BRUNSWICK STEAM ELECTRIC PLANT, UNIT 1

AMENDMENT TO FACILITY OPERATING LICENSE

Amendment No. 183
License No. DPR-71

BRUNSWICK STEAM ELECTRIC PLANT, UNIT 2

Figure 2.2.1-1. APRM Flow Bias Scram Relationship to Normal Operating Conditions

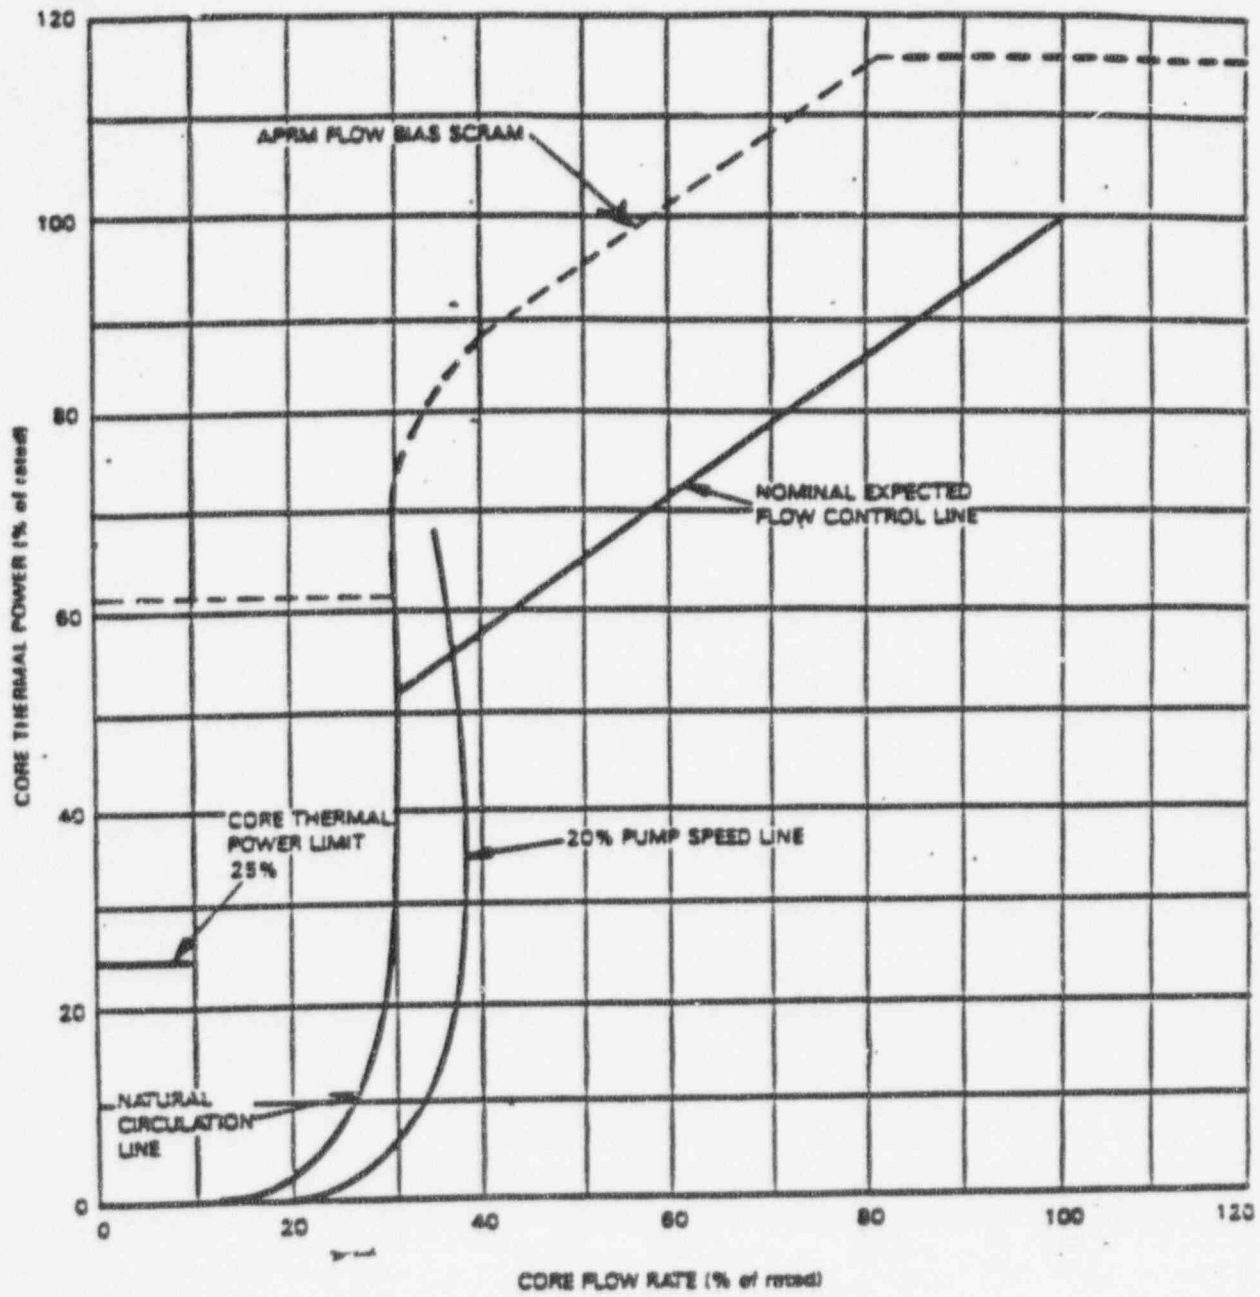
The APRM flow scram trip in the RUN mode consists of a flow biased simulated thermal power (STP) scram setpoint and a fixed neutron flux scram setpoint. The APRM flow biased neutron flux signal is passed through a filtering network with a time constant which is representative of the fuel dynamics. This provides a flow referenced signal, e.g., STP, that approximates the average heat flux or thermal power that is developed in the core during transient or steady-state conditions.

The APRM flow biased simulated thermal power scram trip setting at full recirculation flow is adjustable up to the nominal trip setpoint of 113.6% of RATED THERMAL POWER. This reduced flow referenced trip setpoint will result in an earlier scram during slow thermal transients, such as the loss of 100°F feedwater heating event, than would result with the 116.3% fixed neutron flux scram trip. The lower flow biased scram setpoint therefore decreases the severity, Δ CP, of a slow thermal transient and allows lower operating limits if such a transient is the limiting abnormal operational transient during a certain exposure interval in the fuel cycle.

Figure 2.2.1-1. APRM Flow Bias Scram Relationship to Normal Operating Conditions

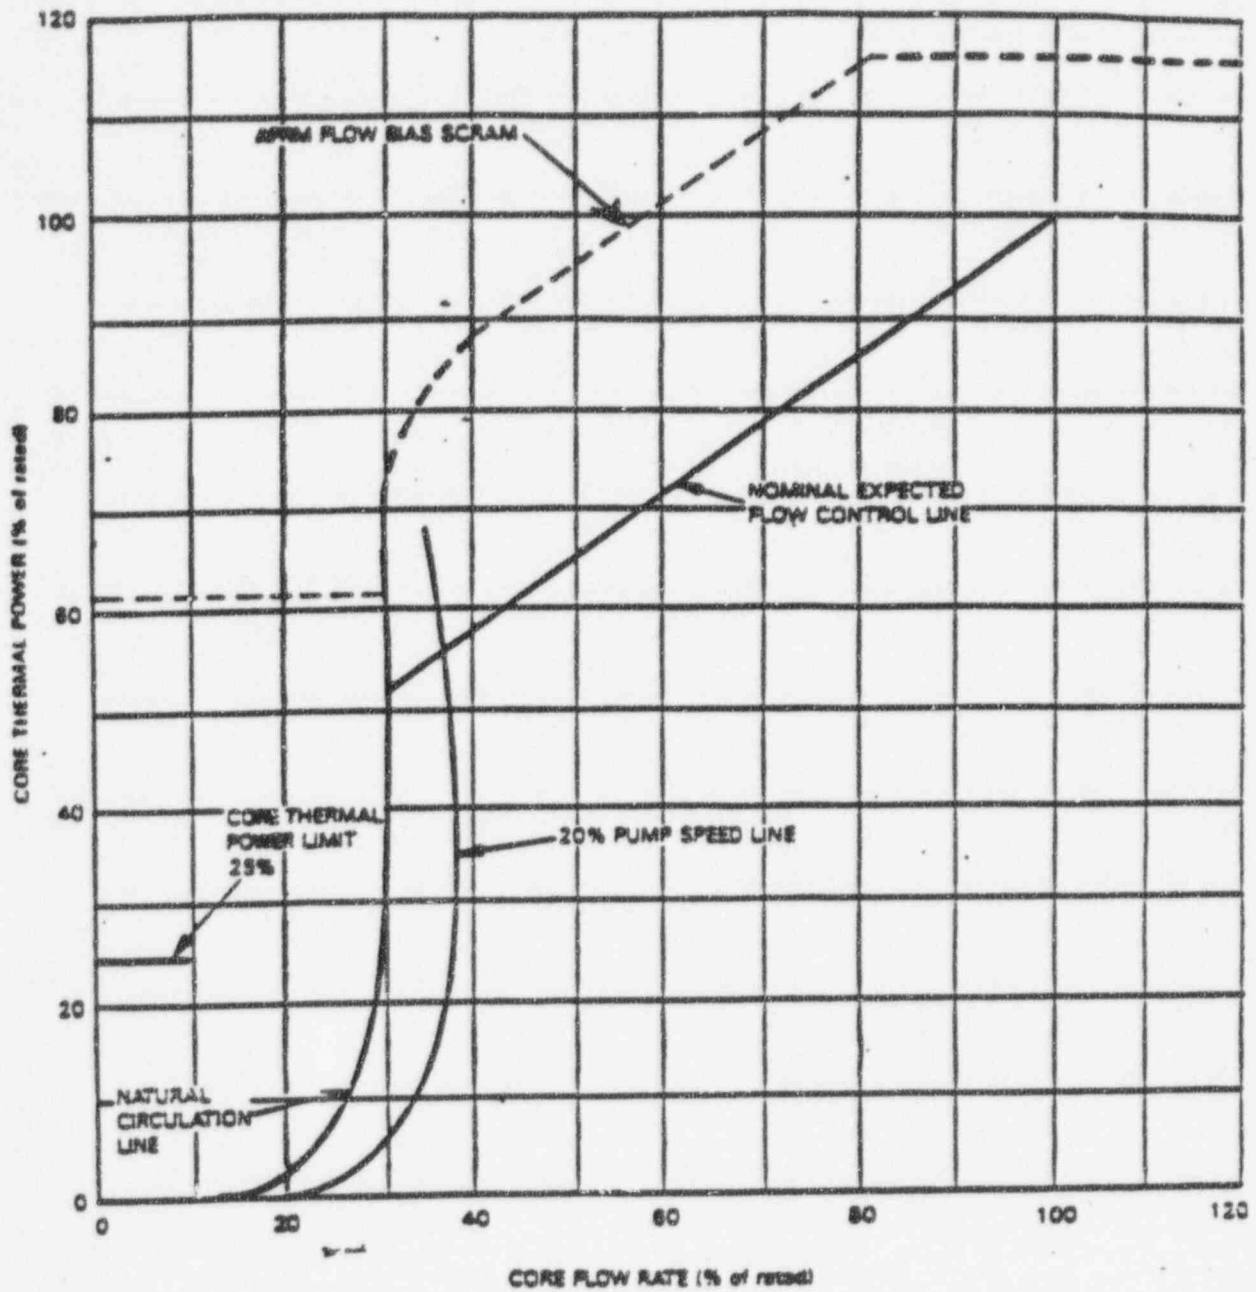
The APRM setpoints were selected to provide adequate margin for the Safety Limits and yet allow operating margin that reduces the possibility of unnecessary shutdown.
